PIC18F87J10 Family Rev. A5/A6 Silicon Errata

The PIC18F87J10 family parts you have received conform functionally to the Device Data Sheet (DS39663F), except for the anomalies described below. Any Data Sheet Clarification issues related to the PIC18F87J10 family will be reported in a separate Data Sheet errata. Please check the Microchip web site for any existing issues.

The following silicon errata apply only to PIC18F87J10 family devices with these Device/Revision IDs:

FIGURE 1: SCKx PULSE VARIATION USING TIMER2/2

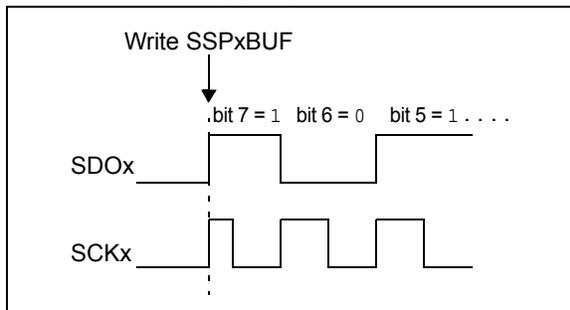
When the SPI is using Timer2/2 as the clock source, a shorter than expected SCKx pulse may occur on the first bit of the transmitted/received data (see Figure 1).

To avoid producing the short pulse:

1. Turn off Timer2.
2. Clear the TMR2 register.
3. Load the SSPxBUF with the data to be transmitted.
4. Turn Timer2 back on.

For sample code, see Example 1.
